<b>Docket Number:</b>	03-AFC-01C
<b>Project Title:</b>	Roseville Energy Park Compliance
<b>TN #:</b>	219887
<b>Document Title:</b>	Petition to Amend the Roseville Energy Park
<b>Description:</b>	N/A
<b>Filer:</b>	Mike Monasmith
<b>Organization:</b>	City of Roseville
<b>Submitter Role:</b>	Public Agency
<b>Submission Date:</b>	6/23/2017 4:33:53 PM
<b>Docketed Date:</b>	6/23/2017

**PETITION FOR STAFF APPROVED MODIFICATIONS  
ROSEVILLE ENERGY PARK**

### Attachment 3 – Concrete Additions

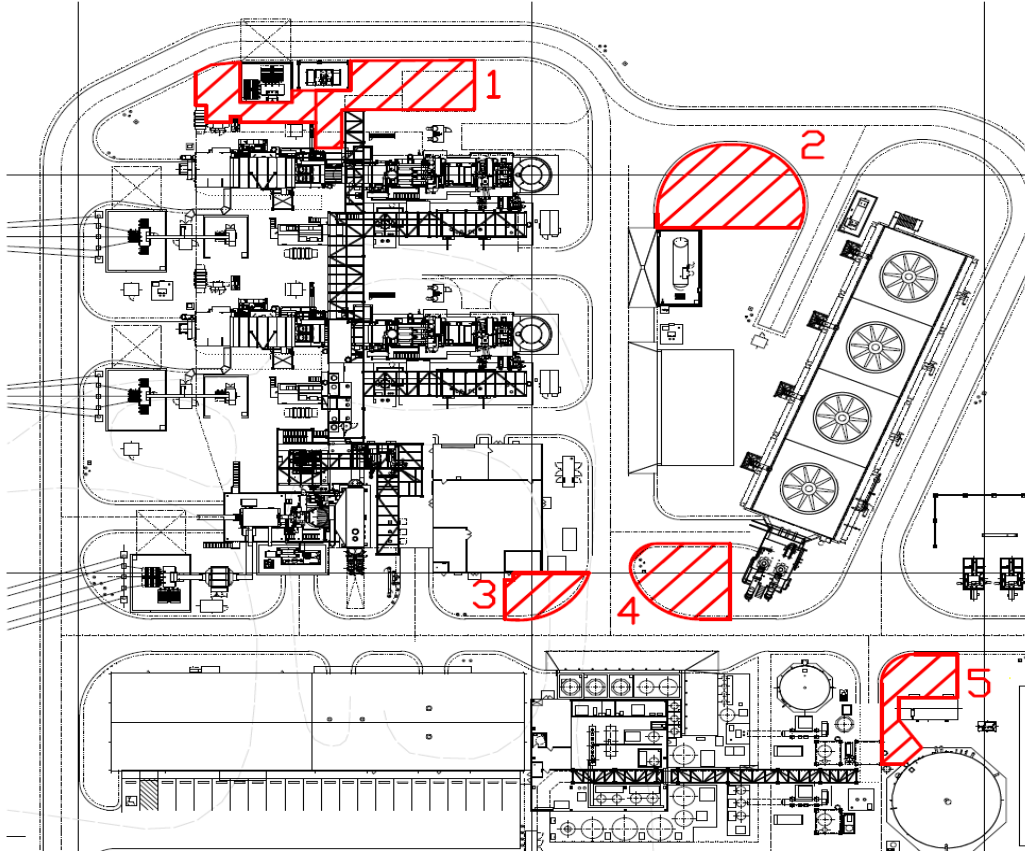
1. Concrete pad #1 is approximately 45' X 145'. It is for general access to the CT package, oil drums and air filters using a forklift or hand truck.
2. Concrete pad #2 is approximately 32' X 85'. It will be used for forklift access to scaffold storage and equipment laydown.

3. Concrete pad #3 is approximately 38' X 29'. It will be used as a pad for garbage and cardboard dumpsters.
4. Concrete pad #4 is approximately 47' X 63'. This additional concrete will allow us to reposition the oil shed allowing forklift access to oil drums.

5. Concrete pad #5 is approximately 70' x 17'. This will allow access to fire pump house and belt press structure including stairway pads.
6. General:
  - a. Depth of ground disturbing activities is expected to be no more than 12" below existing grade.
